ALLAMAKEE CSD MIDDLE SCHOOL HVAC UPGRADE
WAUKON, IOWA

ADDENDUM 02
March 6, 2026

D-101A

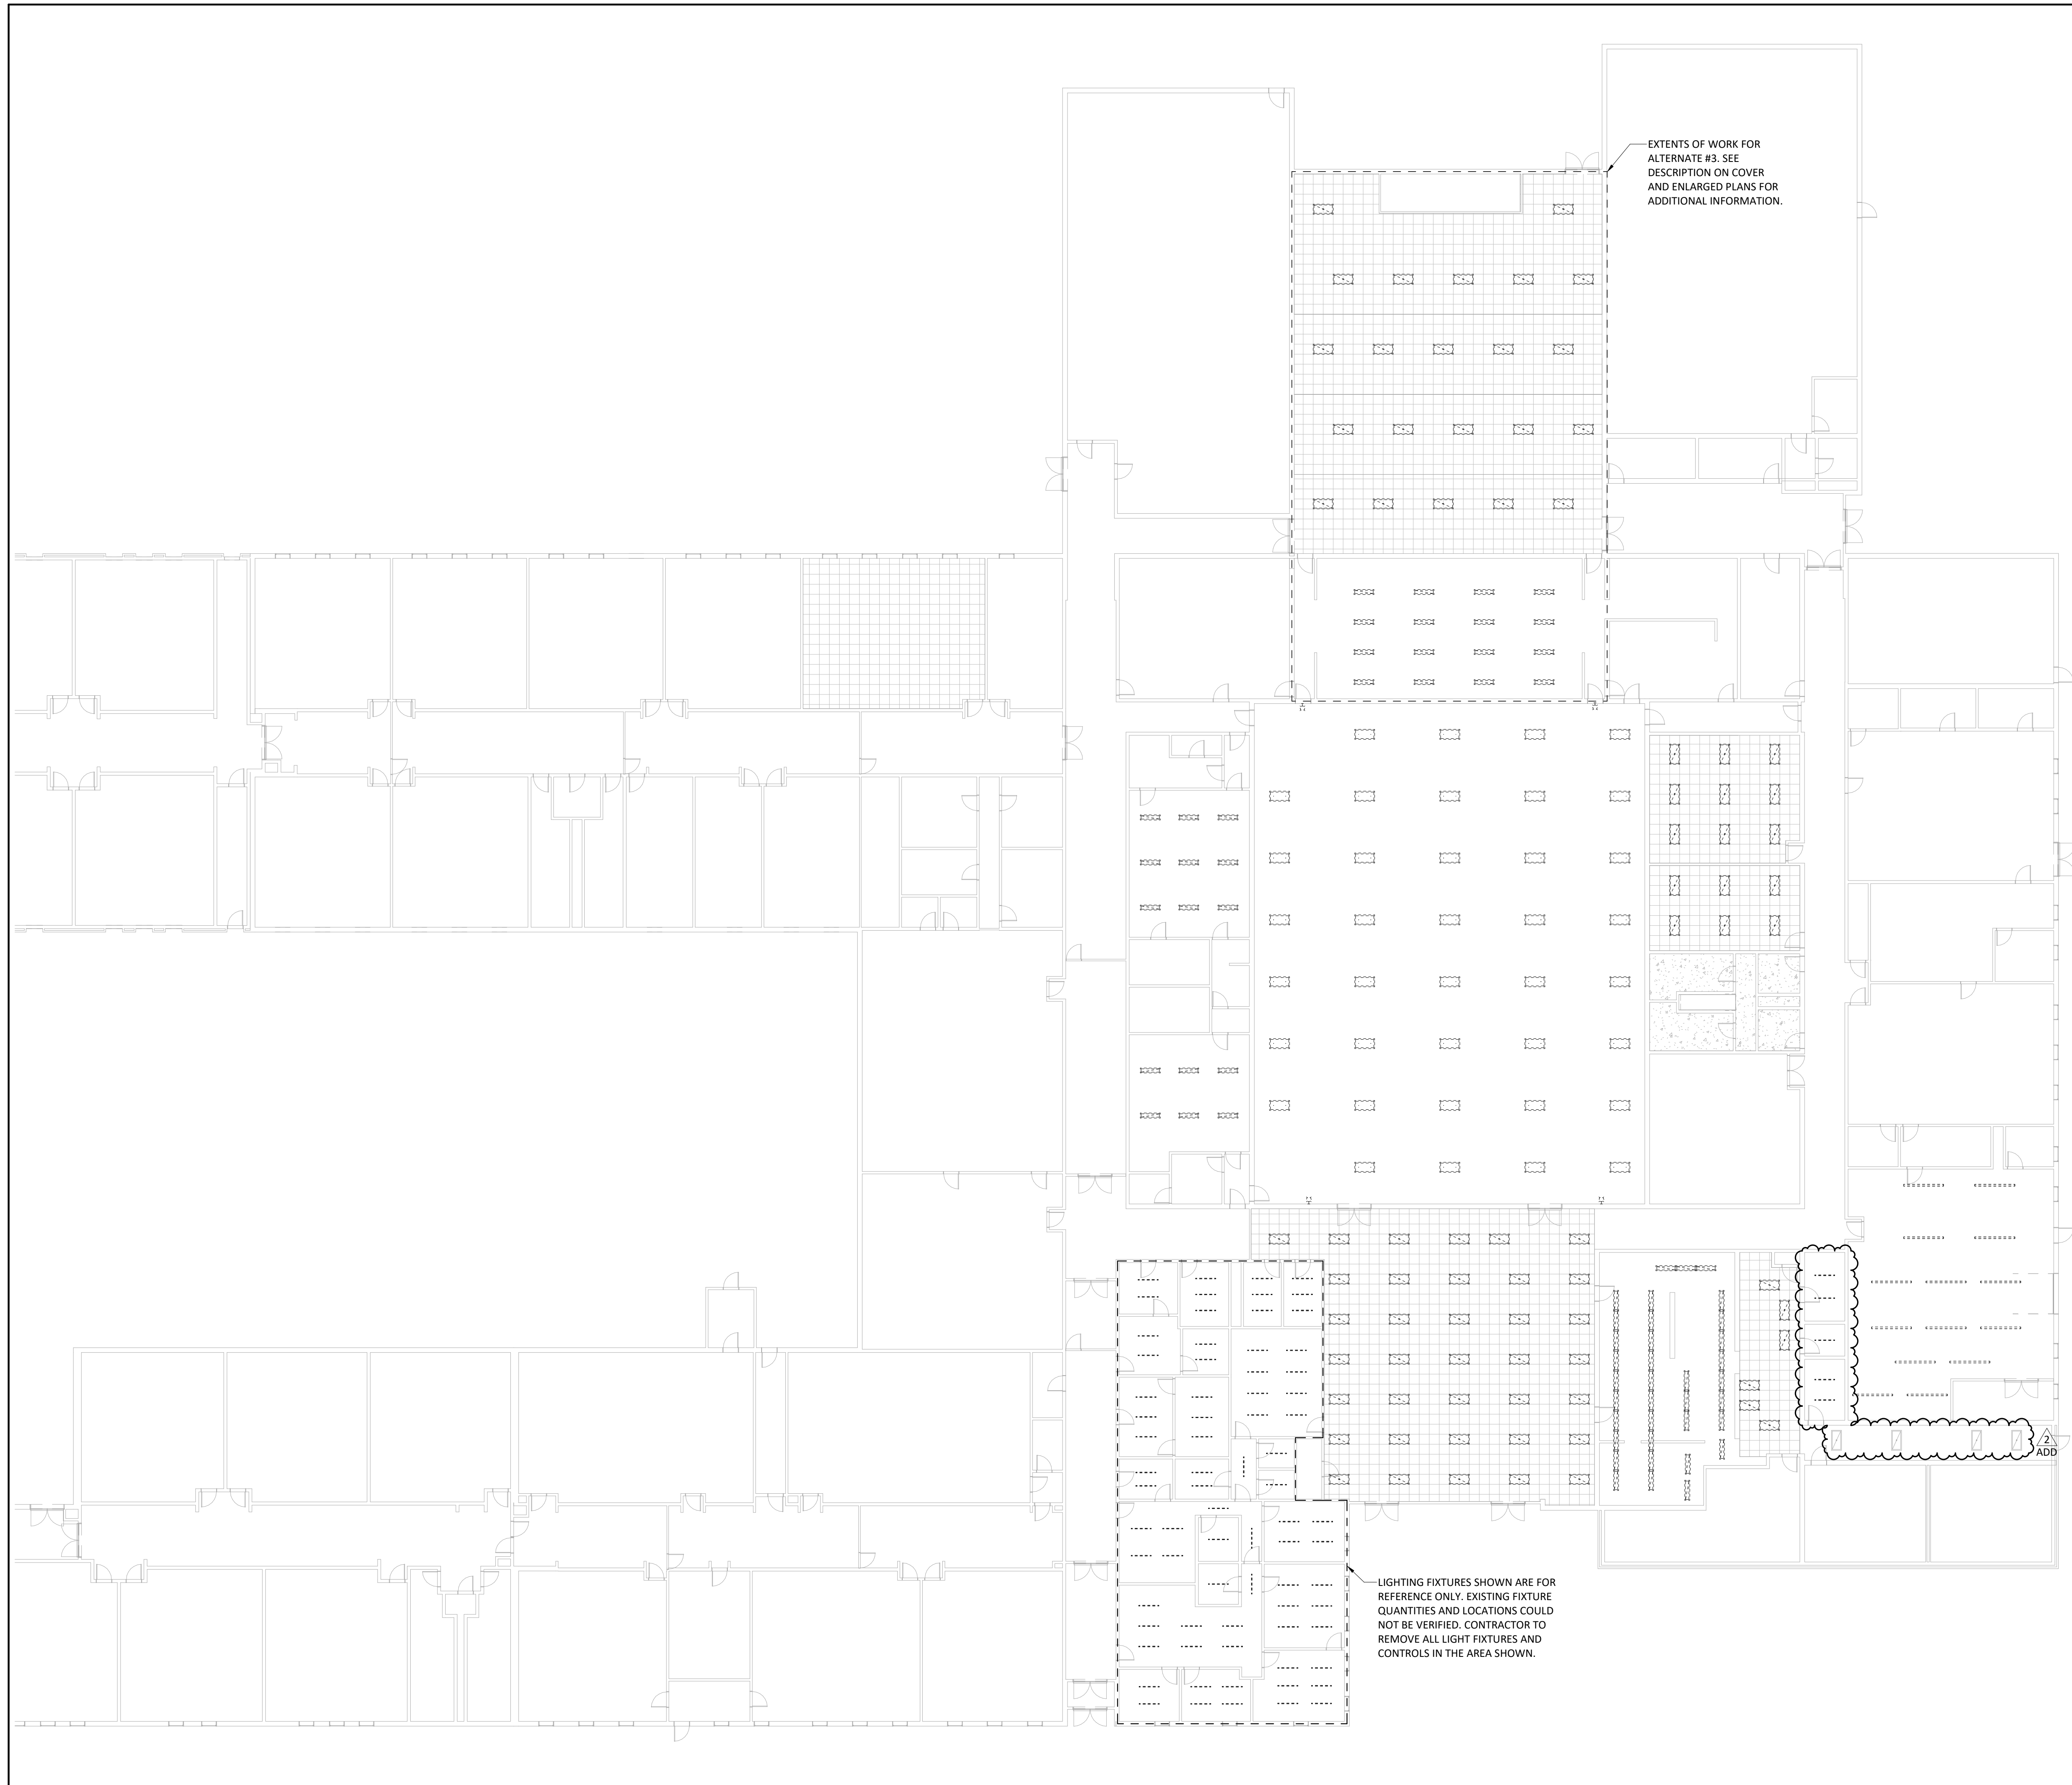
- C2-1 Drawing **COVER SHEET**
1. Added sheet E-505 ELECTRICAL DETAILS
- D2-1 Drawing **D-101A – DEMO MECHANICAL & ELECTRICAL PLAN – AREA A**
1. Added demo for existing UV.

2. Added demo for existing hot water baseboard heaters.
 3. Added notes to patch openings and penetrations of demolished equipment and associated components.

D-110

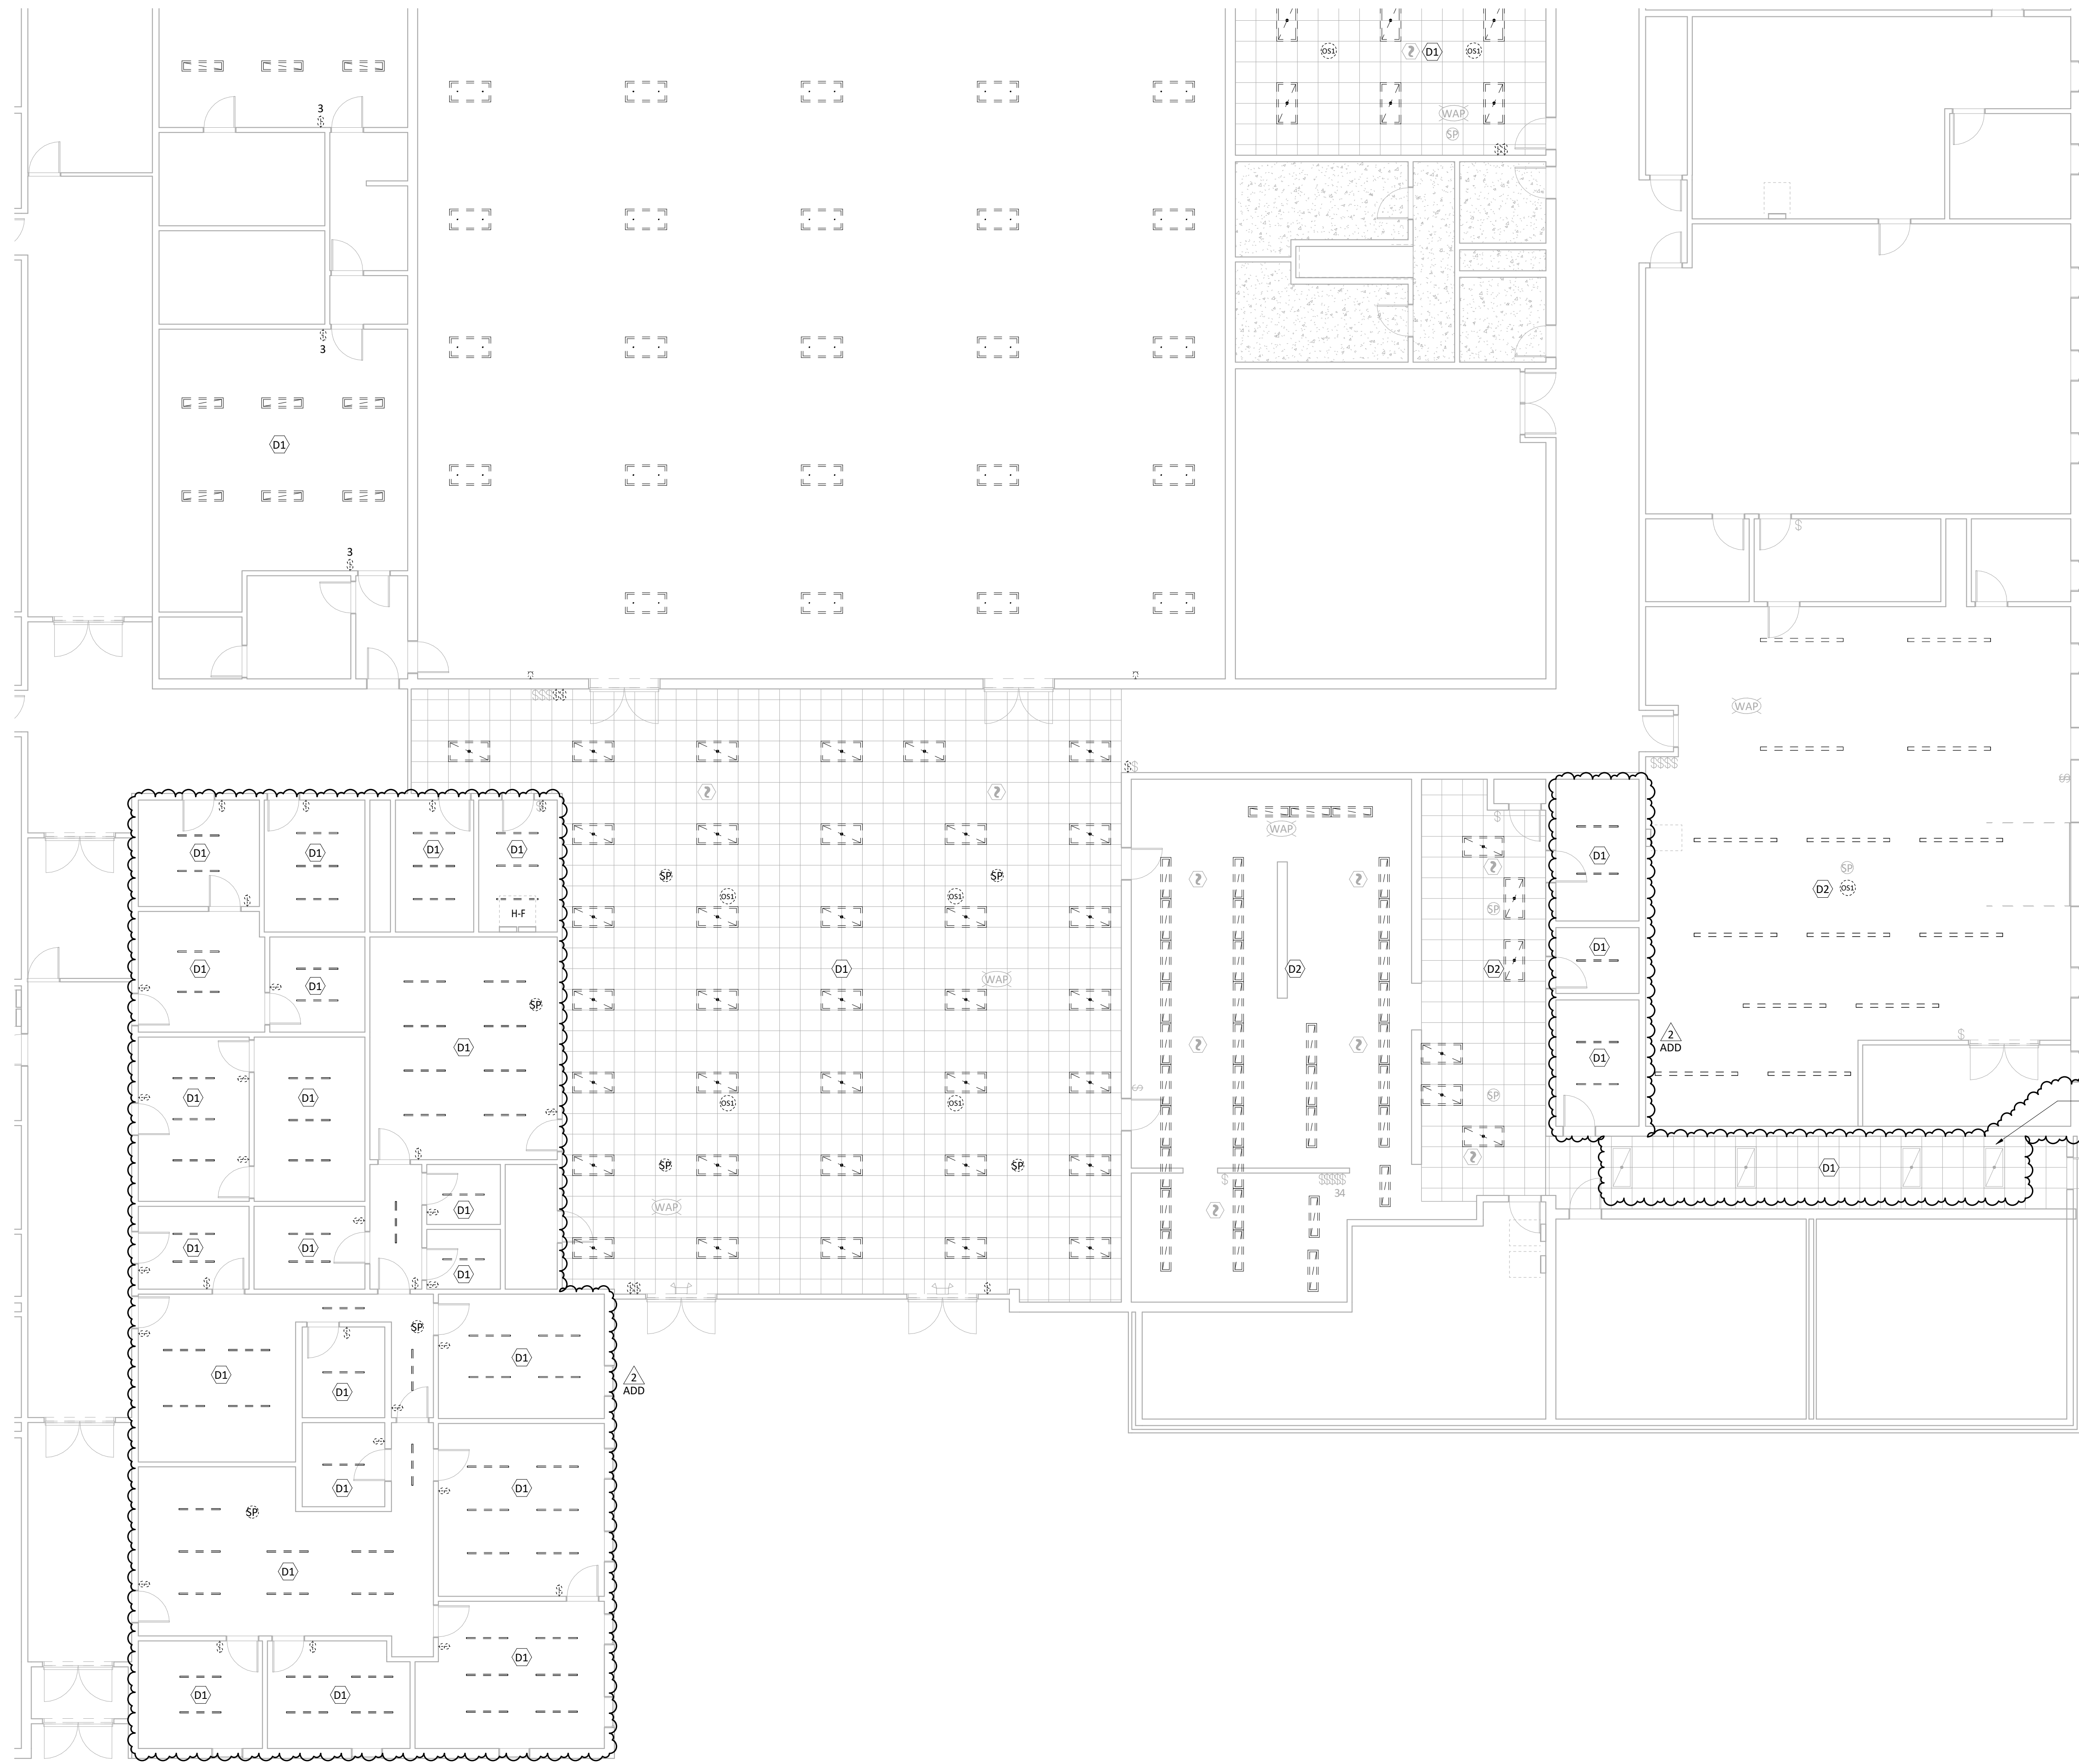
- D2-2 Drawing **D-110 – DEMO LIGHTING PLAN – OVERALL**
1. Added fixtures in kitchen corridor to be removed and replaced.
 2. Added fixtures in kitchen offices to be demolished.
